PRELIMINARY PLAT MIDDLEBROOK MAINSTREET Cumming, Iowa

<u>P & Z Communication: Planning & Zoning Commission Meeting Items for</u> December 19, 2023

CUMMING, IOWA MIDDLEBROOK MAINSTREET PRELIMINARY PLAT

Veenstra & Kimm, Inc. has reviewed the preliminary plat and offer the following comments:

<u>Sheet 1</u>

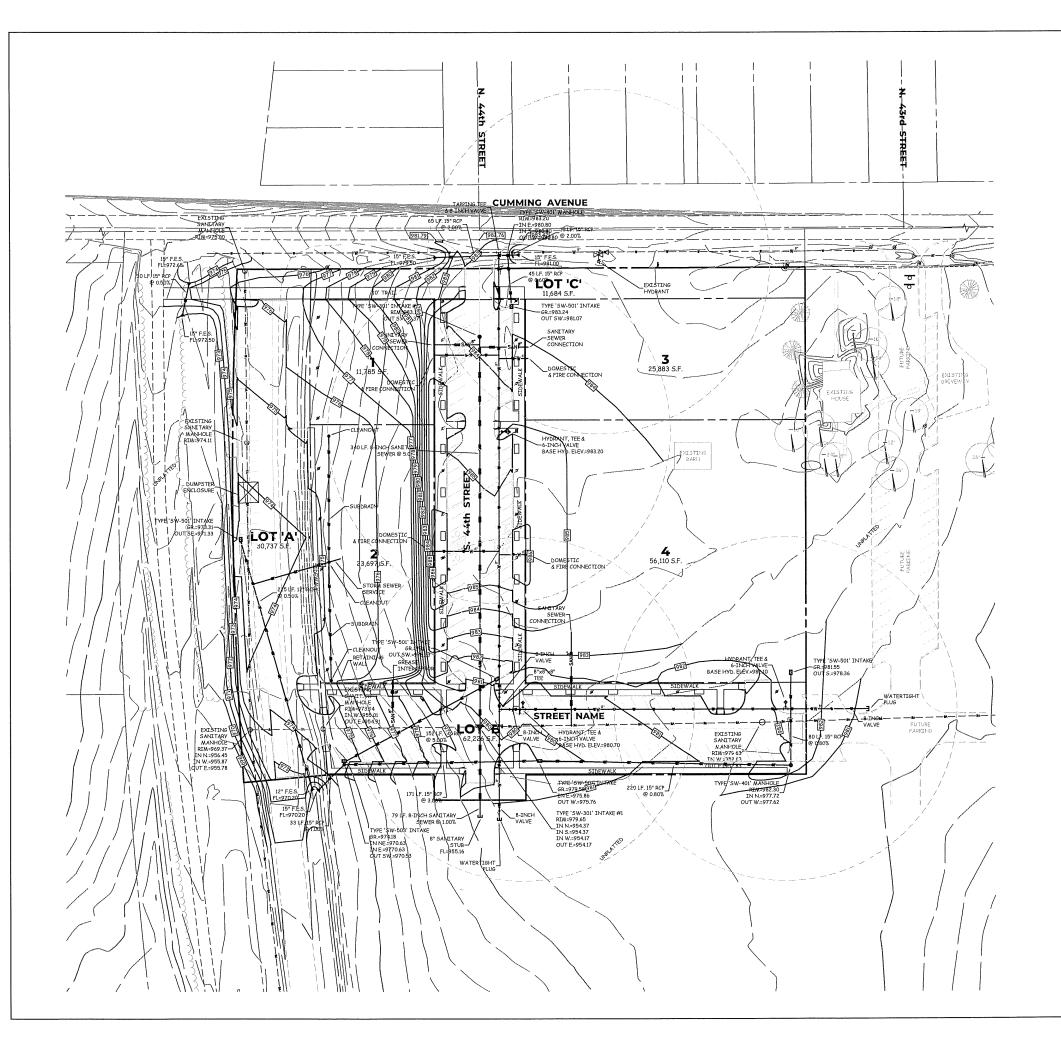
- 1. Show graphically for each lot the building setback lines (BSL) width as shown under "Setbacks" label on Sheet 1.
- 2. Provide typical sections showing jointing and pavement thickness of the streets.
